Product Support Bulletin 2009-008

Maintenance of Way ~ Work Equipment Bulletin

SUBJECT: Cab Tube Upgrade Kit – 98760059

**MACHINE
MODEL(S):** TRIPP

Figure 1

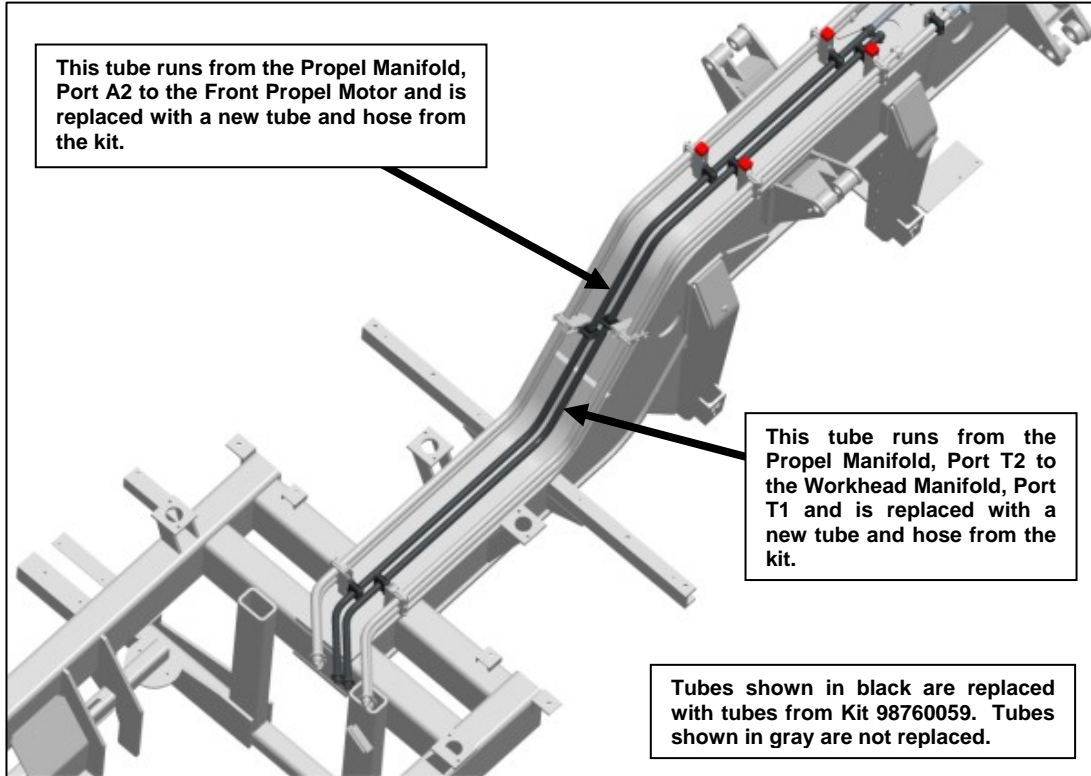
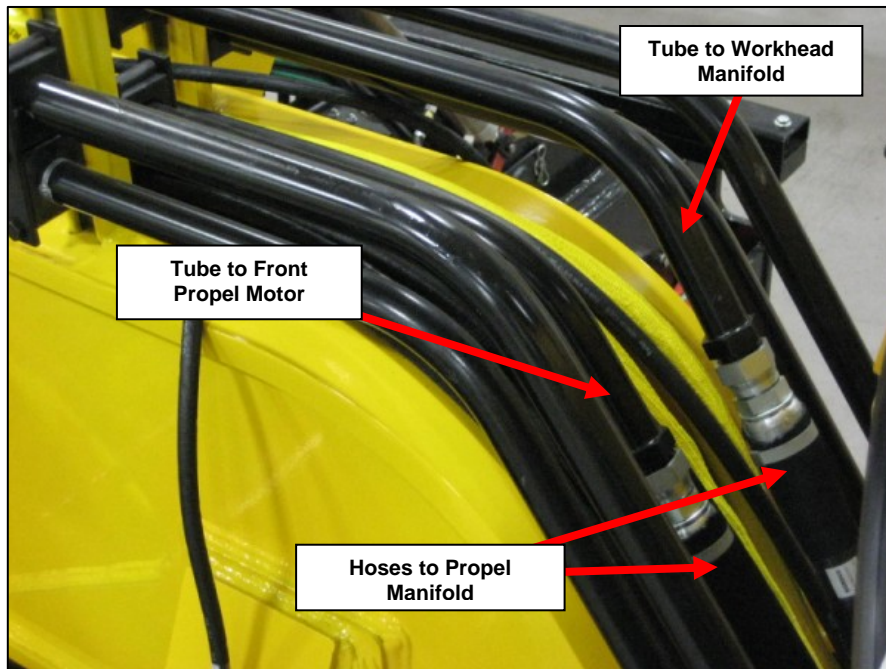
SUMMARY: The tubes connecting the Propel Manifold to the front Travel Motor and Workhead Manifold run under the cab of the machine and are difficult to replace without removing the cab. See Figure 1 on Page 2. Kit 98760059 includes hoses that replace the section of the tubes under the cab and new tubes for the top of the frame. See Figure 2 on Page 2.

ACTION: There are 2 options for installing this kit. For Option 1, the tubes are cut just in front of the cab and the tube section on top of the frame is removed and replaced with the tubes from the kit. The kit hoses are routed under the cab next to the remaining section of the old tube and are connected to the Propel Manifold and the new tubes.

For Option 2, the cab is removed and the existing tubes are removed entirely and replaced with the tubes and hoses from the kit. In both options, the existing clamps are used to retain the new tubes. Machines with serial numbers of 760334 and higher have been modified at the factory and do not require this kit.
